Subject: Safety Recall 04V-444
(Ford Number 04S22)

SUBJECT: DEMONSTRATION / DELIVERY HOLD: Safety Recall 04S22:
Certain 2003 and 2004 Model Year E-Series Vehicles
Anti-Lock Brake System (ABS) Module Service

CERTAIN 2003 AND 2004 E-SERIES VEHICLES — ANTI-LOCK BRAKE SYSTEM (ABS) MODULE SERVICE

FIGURE 1

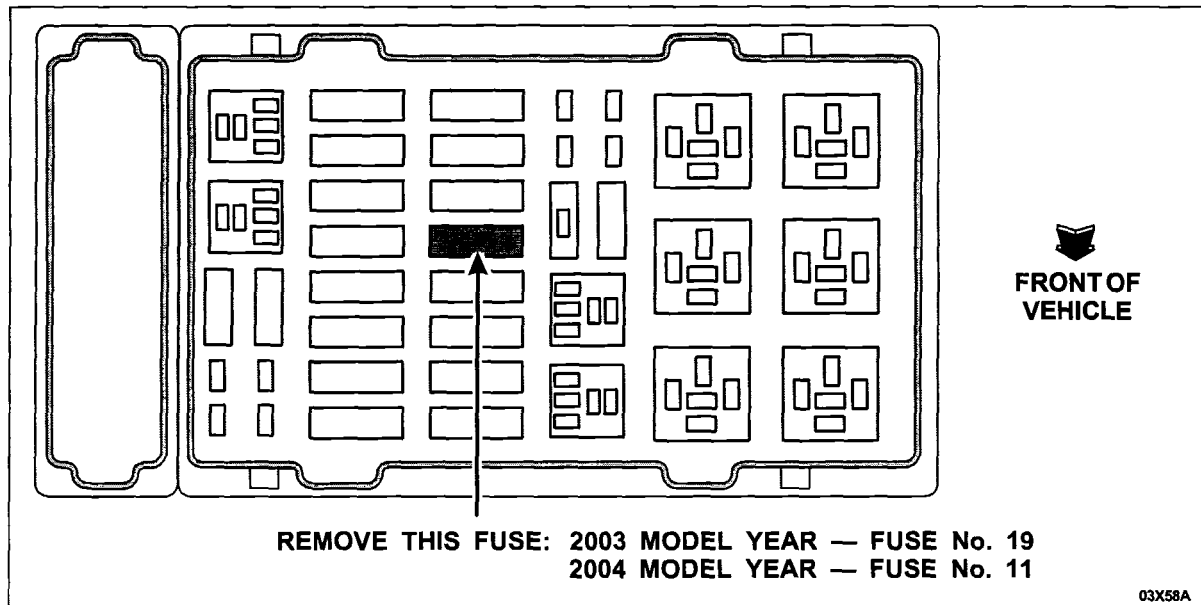
1. Open the hood and remove the PDB cover.
2. Locate and remove the 4 wheel anti-lock brake system (4WABS) 60 amp (blue) fuse.

NOTE: Although the 2003 and 2004 PDB appear to be identical and are in the same physical location, the fuse locations have different numbers. See Figure 1.

3. Install a **new** 30-amp (green) fuse in place of the original 60-amp (blue) fuse.
4. Install the PDB cover.

FIGURE 2

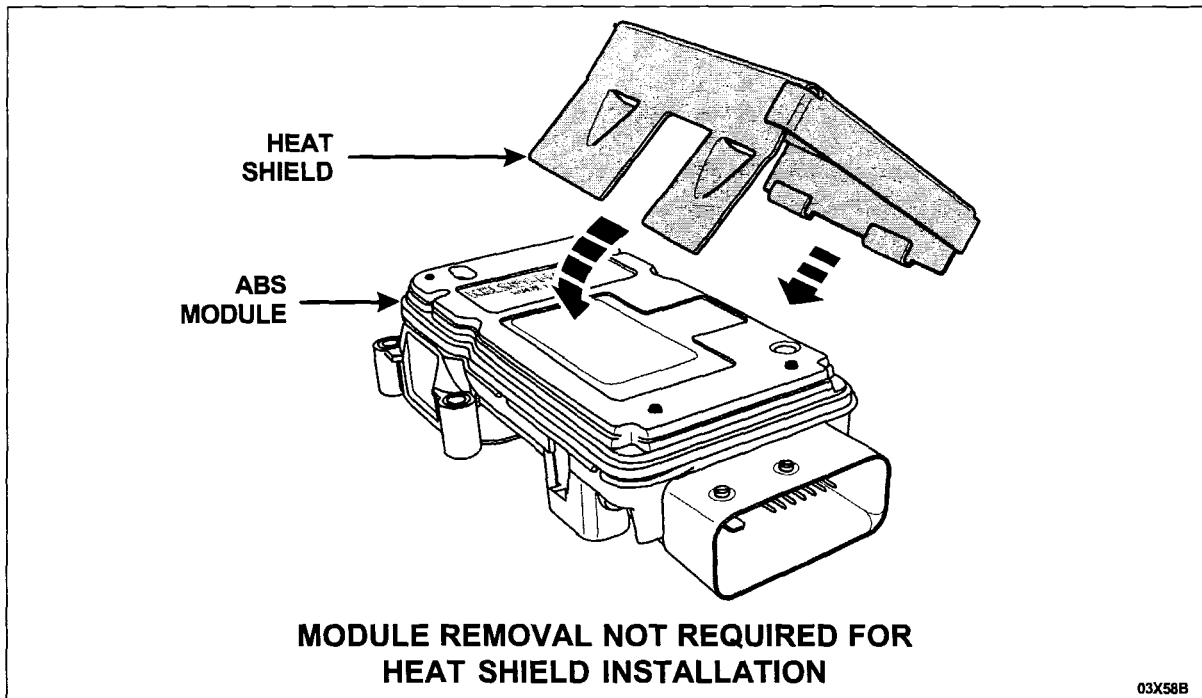
5. Install the ABS Module heat shield as follows:

- a) Hold the radiator coolant reservoir hose out of the way.
- b) Position the heat shield so it will fit securely against the connector-side of the module, set the retaining hooks under the lip of rear side of the module, then rotate the shield downward to snap it into place. See Figure 2.

FIGURE 3

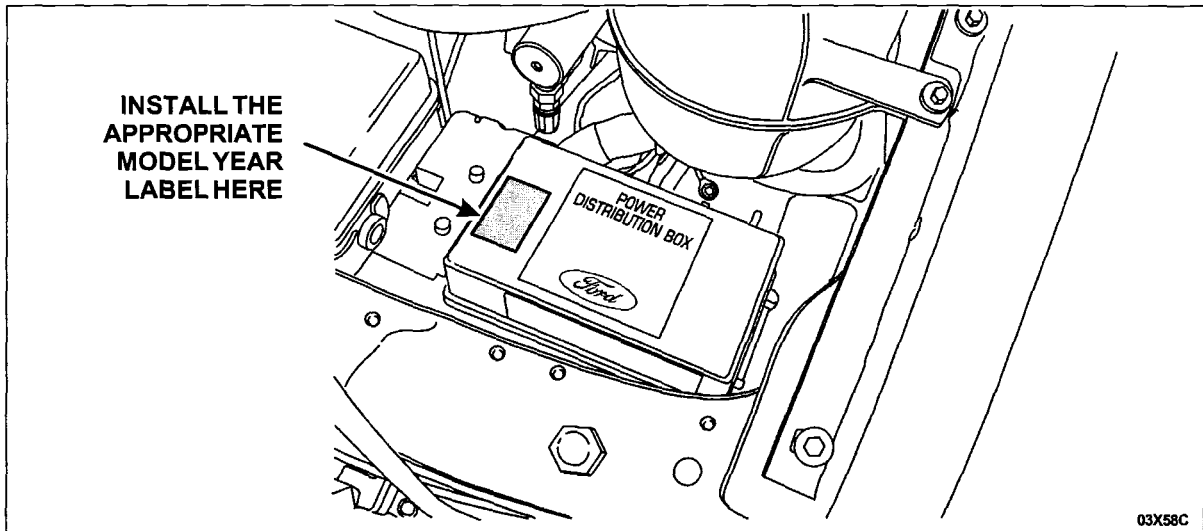
6. Clean the PDB cover and install the supplied PDB cover label. See Figure 3.

FIGURE 4

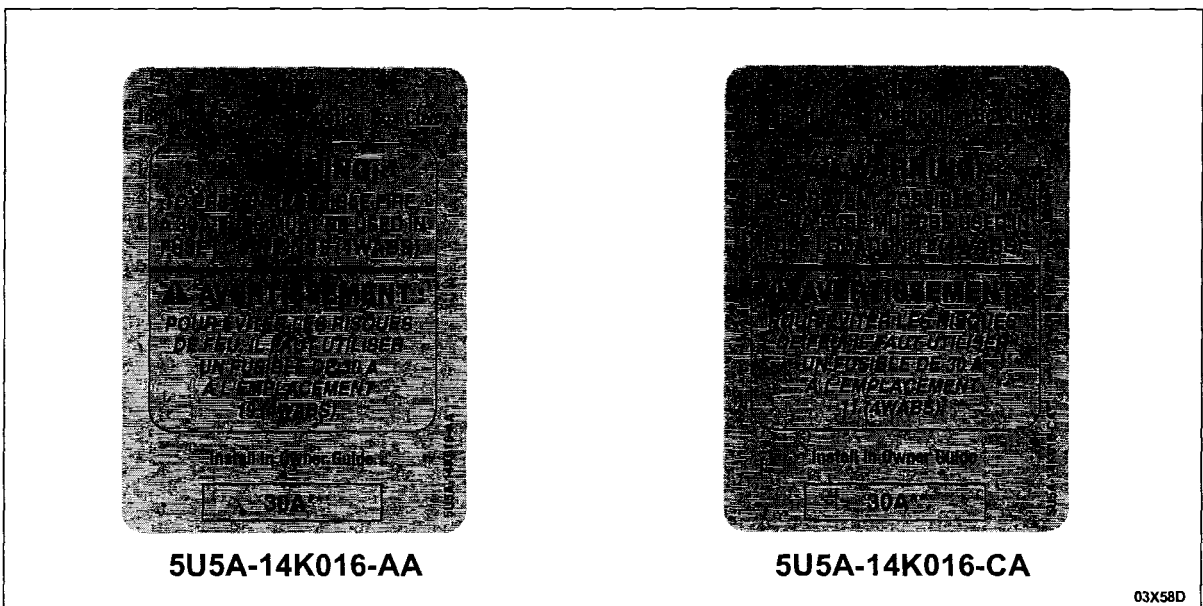
NOTE: Two sheets of labels are provided in the service kit. One sheet is for 2003 model year vehicles and one for 2004 model year vehicles. Use the appropriate model year sheet and discard the remaining sheet. See Figure 4.

- One (1) label for the top of the Power Distribution Box (PDB). (WARNING LABEL)
- One (1) label to install in the Owner Guide. (30A** LABEL)

FIGURE 1

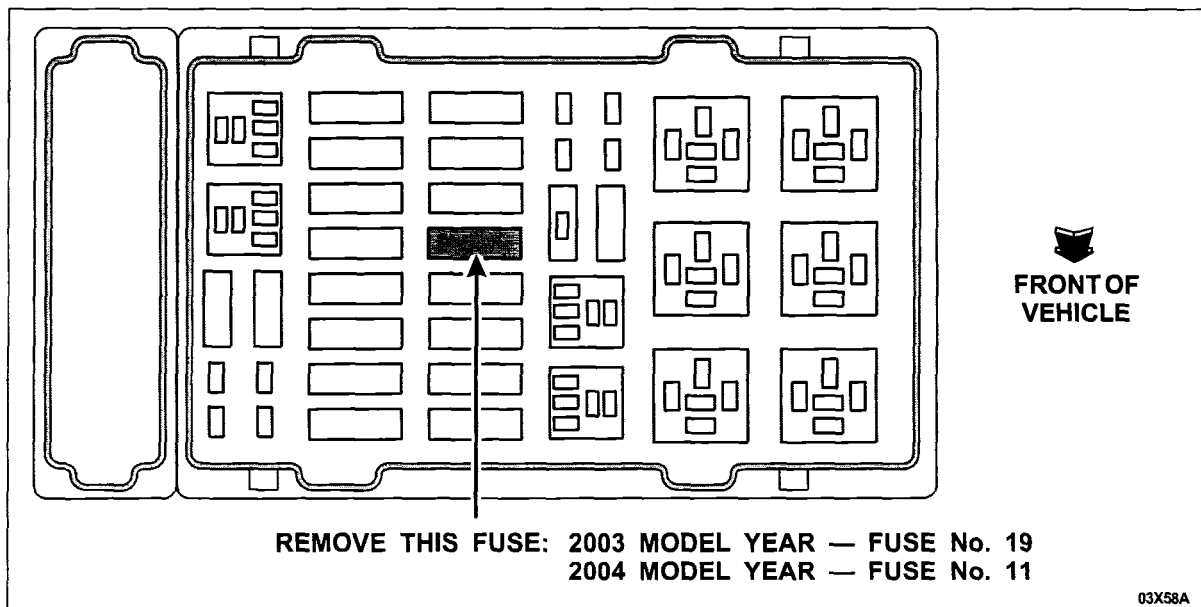
NOTE: On certain models, the PDB may be mounted opposite of how it is shown in Figure 1. Be sure to identify and replace the correct fuse.

NOTE: Although the 2003 and 2004 PDB appear to be identical, the fuse locations have different numbers. See Figure 1.

3. Install a **new** 30-amp (green) fuse in place of the original 60-amp (blue) fuse.

FIGURE 4

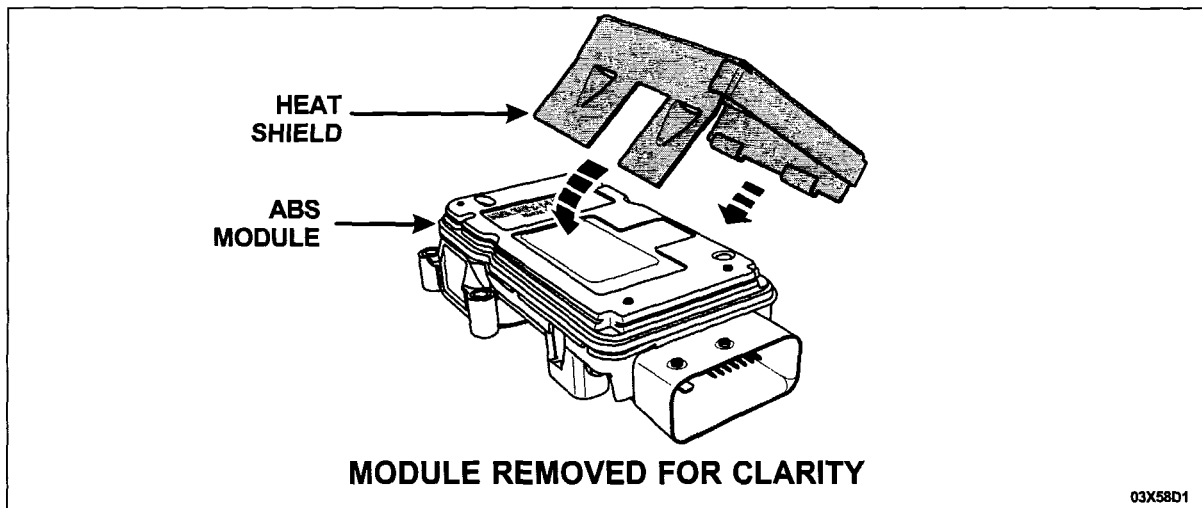
1. If required for access to install the heat shield, disconnect the speed control deactivation switch located at the bottom of the master cylinder.
2. Install the ABS Module heat shield as follows:
 - a) Clean the top of the ABS module with the alcohol pad provided in the service kit.
 - b) Hold the radiator coolant reservoir hose out of the way.
 - c) Position the heat shield so it will fit securely against the connector side of the module, set the retaining hooks under the lip of the rear side of the module, then rotate the shield downward to snap it into place. See Figure 4.

FIGURE 8

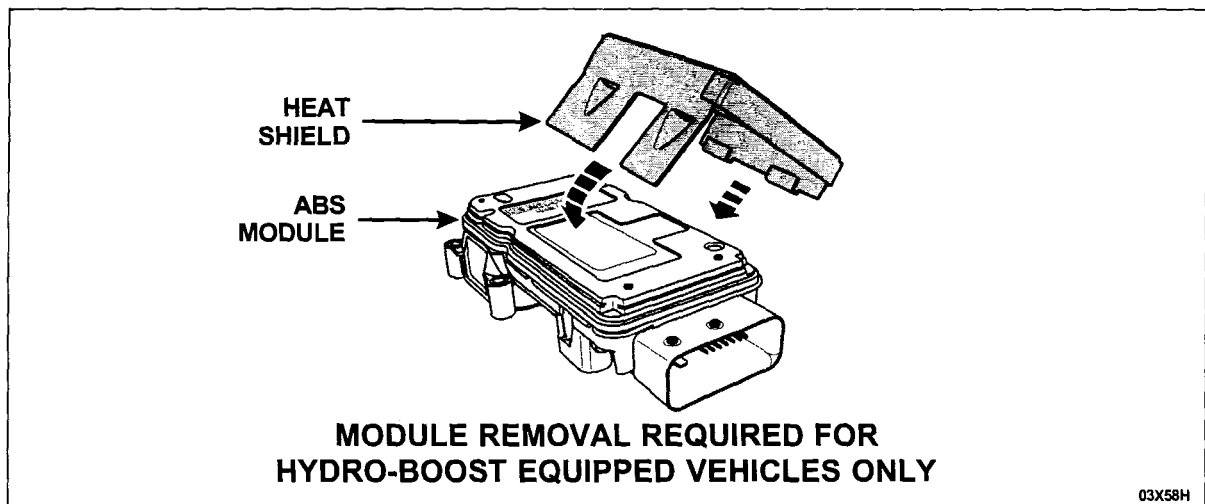
6. Install the ABS Module heat shield as follows:
 - a) Clean the top of the ABS module with the alcohol pad provided in the service kit.
 - b) Position the heat shield so it will fit securely against the connector side of the module, set the retaining hooks under the lip of the rear side of the module, then rotate the shield downward to snap it into place. See Figure 8.
